Final Plat
SUBDIVISION REPORT

S/D No.: 84-23 Name: SYCAMORE VILLAGE 4TH ADDITION

Re: S/D 84-23 - Final Plat of Sycamore Village 4th Addition

FINAL PLAT OF SYCAMORE VILLAGE 4TH. ADDITION

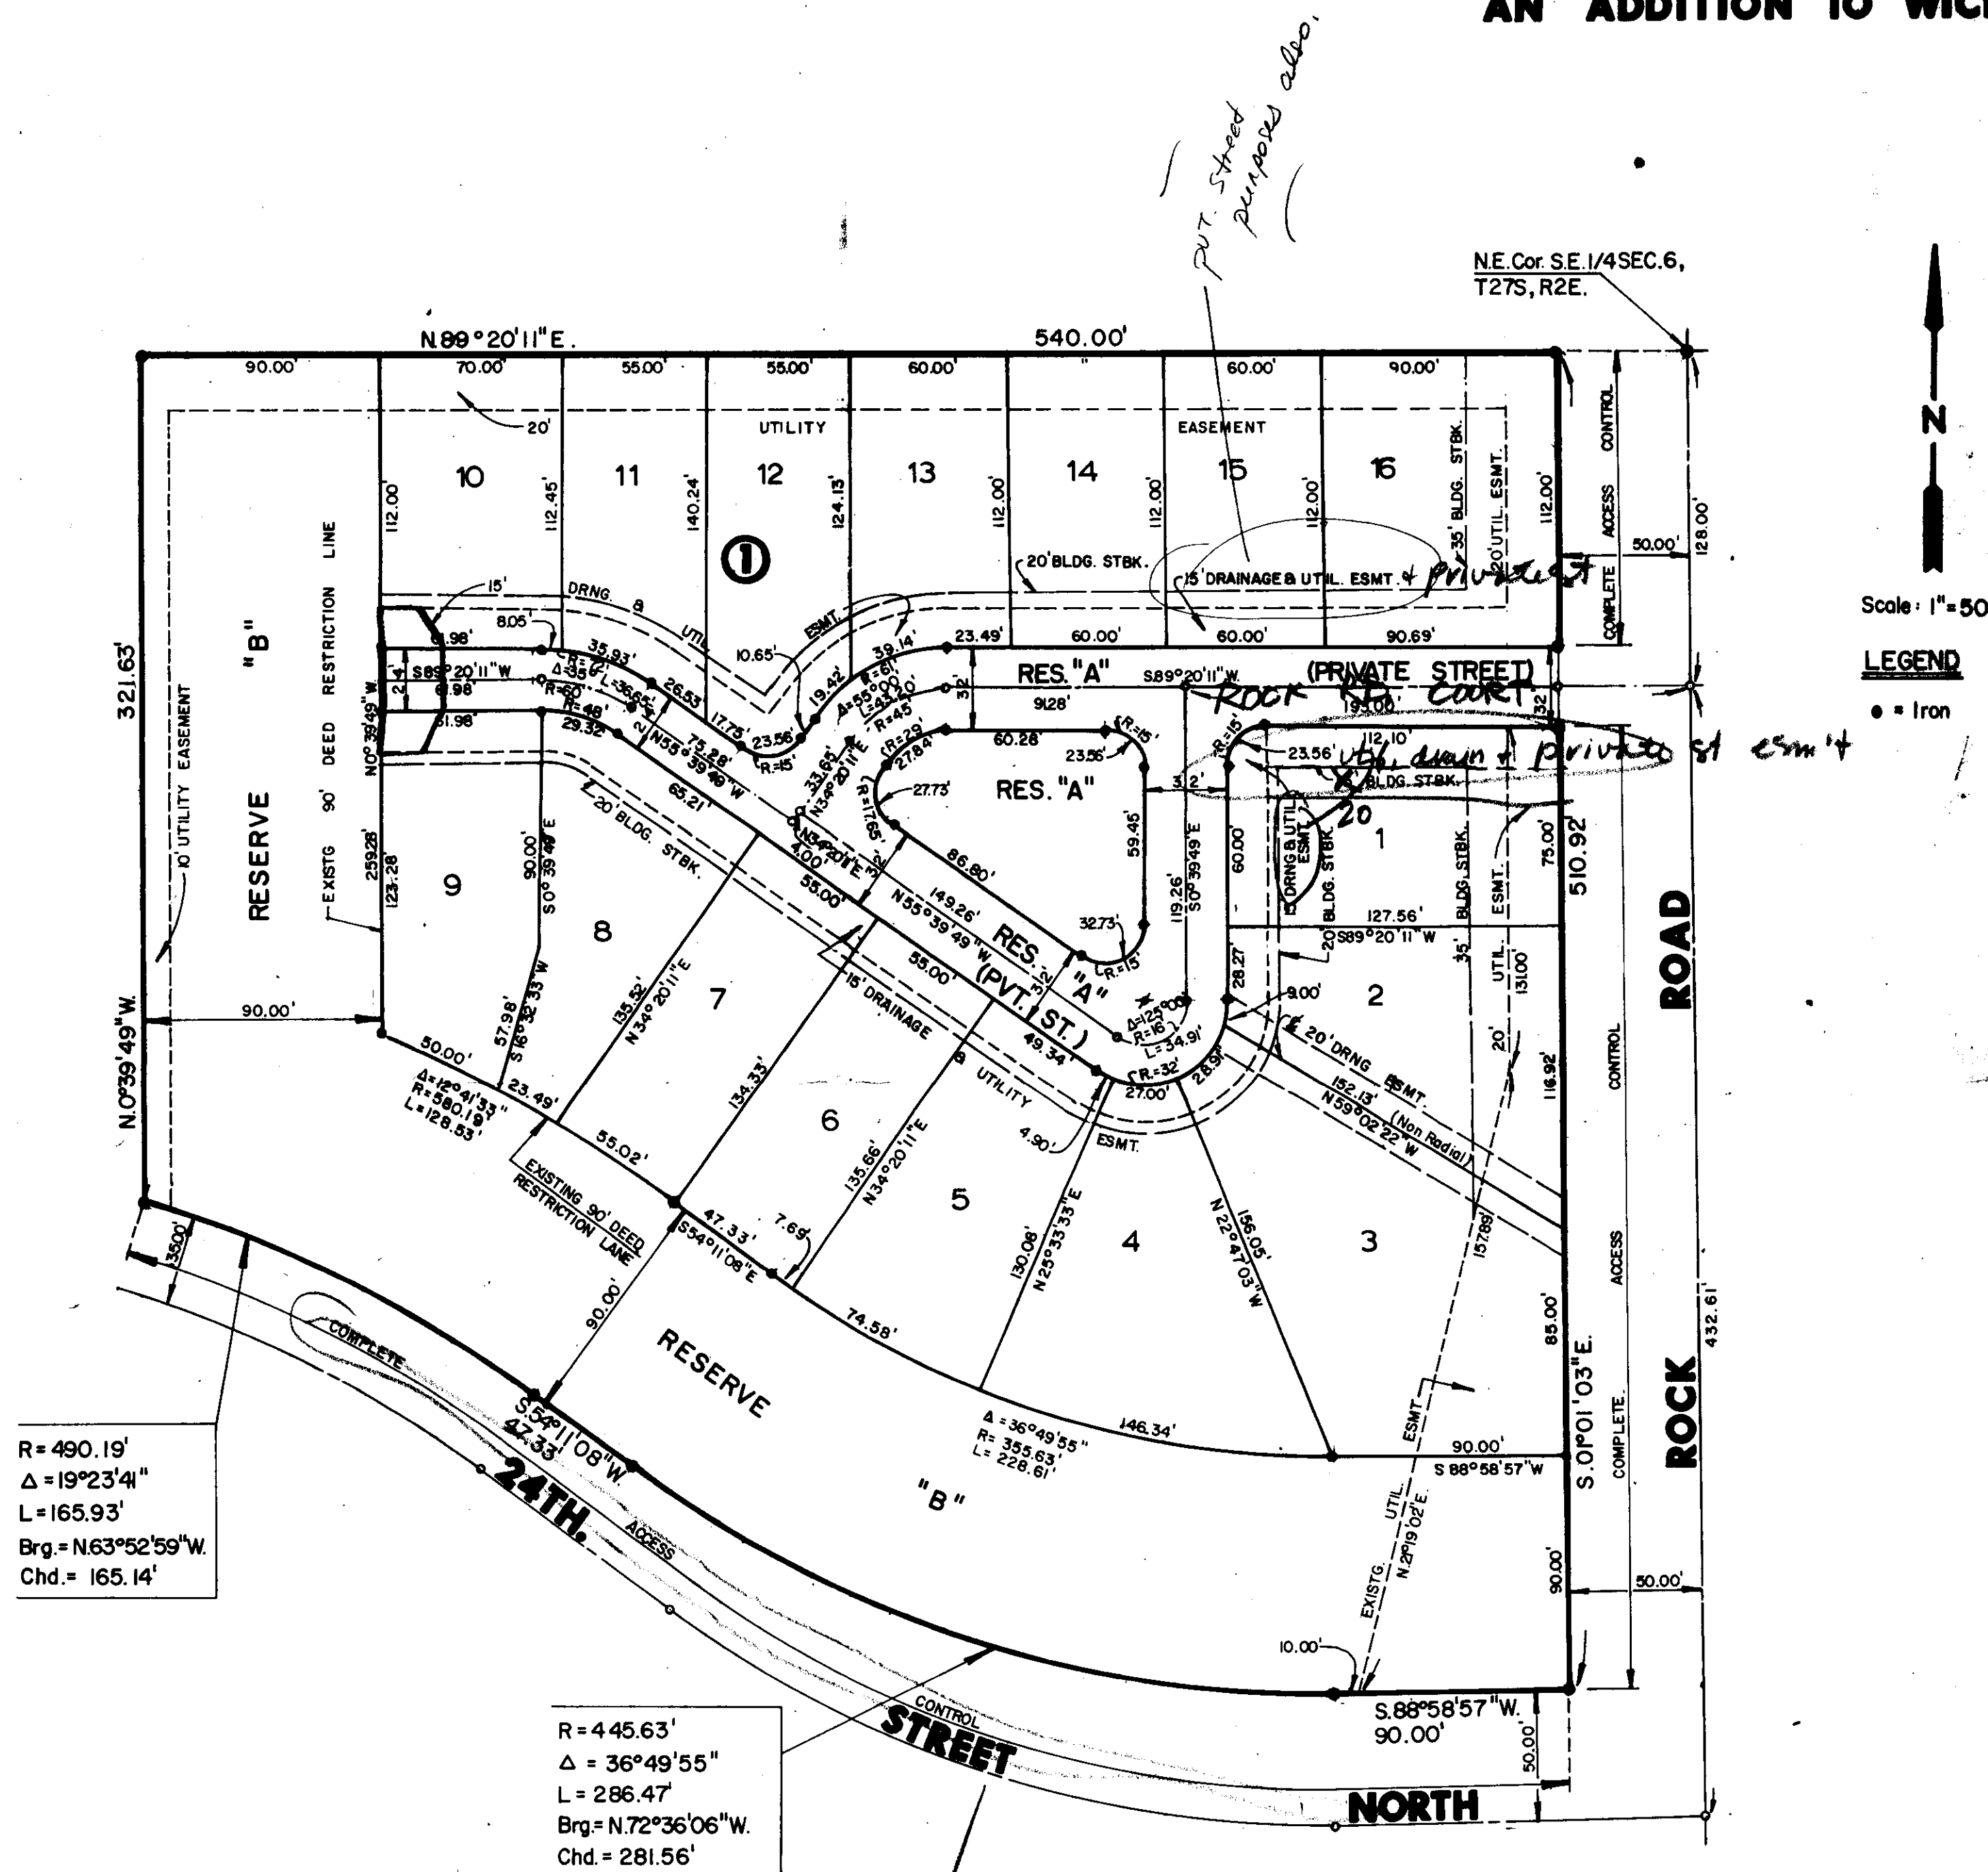
- L. The applicant shall submit the standard avigational easement and restrictive noise covenant for this entire property.
- M. On the final plat tracing, a 15-foot utility, drainage and private street easement shall be indicated adjacent to the north line of Lot 1, Block 1.

- N. On the final plat tracing, the legal description in the engineer's text shall be corrected to reference that this is a replat of Lot 10, Block 4, Sycamore Village 3rd Addition, not Sycamore Village 4th Addition.

- O. On the final plat tracing, the platlor's text shall be amended to reference the platting of "complete access control" to 24th Street North across the south line of this plat.

- P. The final plat tracing shall indicate a 20-foot building setback on Lot 1, Block 1 from that lot's north line. This is needed in order to maintain at least a 5-foot separation between the future building and the drainage and private street easement. This will allow landscaping along the north wall of the future building.

- F. The final plat tracing shall indicate a hammerhead turnaround for the deadend street shown on the preliminary plat.
- G. Provisions will need to be made for ownership and maintenance of the Reserves. The applicant shall either form a homeowners' association prior to recording the plat or shall submit a covenant stating when the association will be formed, when the reserves will be deeded to the association and who is to own and maintain the reserves prior to the association taking over these responsibilities.

- H. On the final plat tracing, the labeling of the 15-foot easement adjacent to the outside of Reserve "A" shall be corrected to read "15-foot utility, drainage and private street easement."

- I. The final plat tracing shall label the name of the proposed private street as "Rock Road Court."
- J. The applicant shall submit a covenant requiring four (4) off-street parking spaces per dwelling unit in this plat.

- K. The applicant shall submit restrictive covenants which call out restrictions for lot-owner use of the 15-foot utility, drainage and private street easement adjacent to Rock Road Court. Retaining walls and change of grade shall be prohibited within these easements as well as fences, earth berms and mass plantings.
